P-24E506

636 BW & 637 CW TELEPHONE SETS

ISSUE. 3

LABEL, WIRING & CIRCUIT

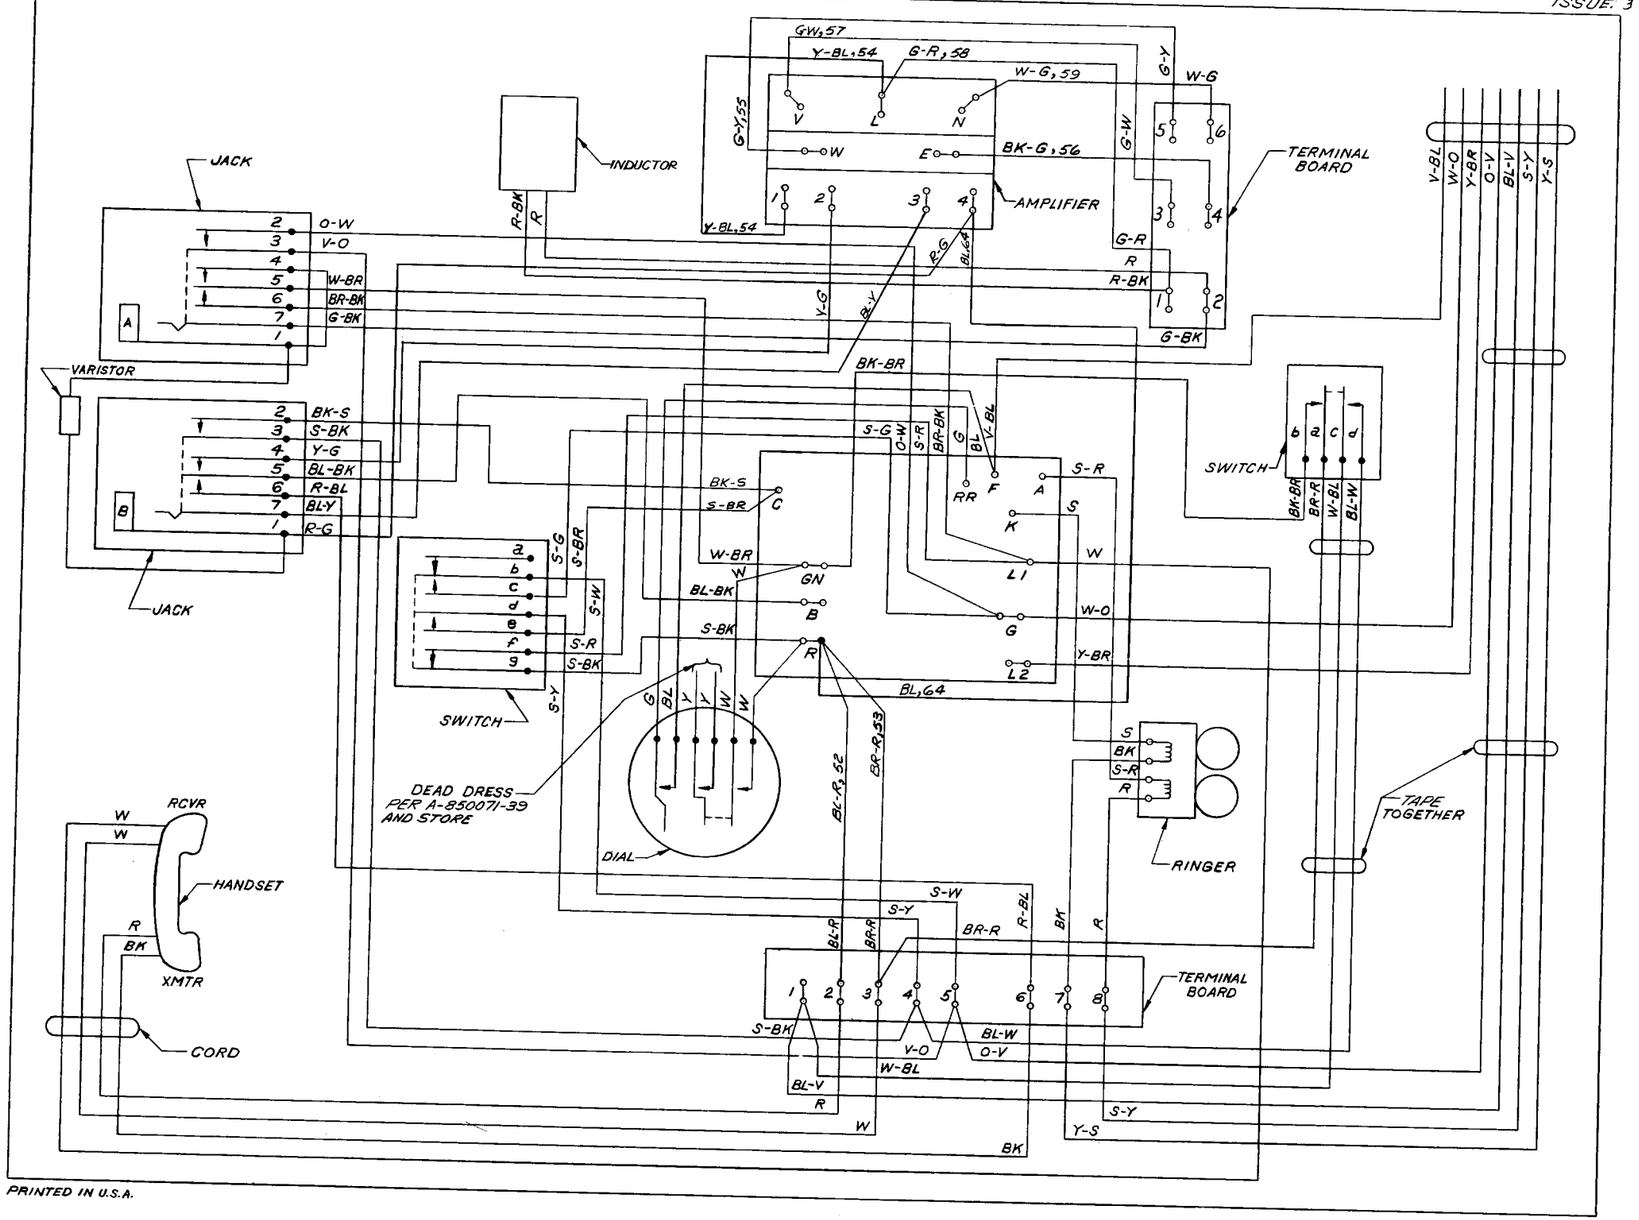
P-24E506		
DRAWN IN ENGLAND		
DRAWN		
ISSUE IL 4-13-62		
7-2-62	ISSUE-1	
CHANGED: BK-S FROM T 2 OF JK B WAS CONN TO T 2 OF AMPL; Y-BL WAS CONN. FROM T 3 OF AMPL. TO T F OF NET; V-BL WAS CONN TO T 4 OF AMPL; BL-Y FROM T 7 OF JK B WAS CONN. TO T E OF T BD; R-G FROM T 1 OF JK B WAS CONN TO T 1 OF AMPL; BK-BL WAS CONN. BETWEEN T 1 OF AMPL & T C OF NET; Y-G FROM T 4 OF JK B WAS CONN TO T 2 OF AMPL; S-BR FROM T E OF SW WAS CONN TO T 2 OF AMPL; ISSUE OF CIRCUIT LABEL WAS 1		
ADDED: BL-G4 LEAD REMOVED: LEAD FROM BETWEEN T 1 & T 7 OF JK B		
LERED 443405AICF		
10-1-63	2	
CHANGED: AT NETWORK S-R & S-BR LEADS WERE SHOWN SOLDERED CIR. LABEL WAS ISS. 2		
DB 591052 D		
10-3-63	3
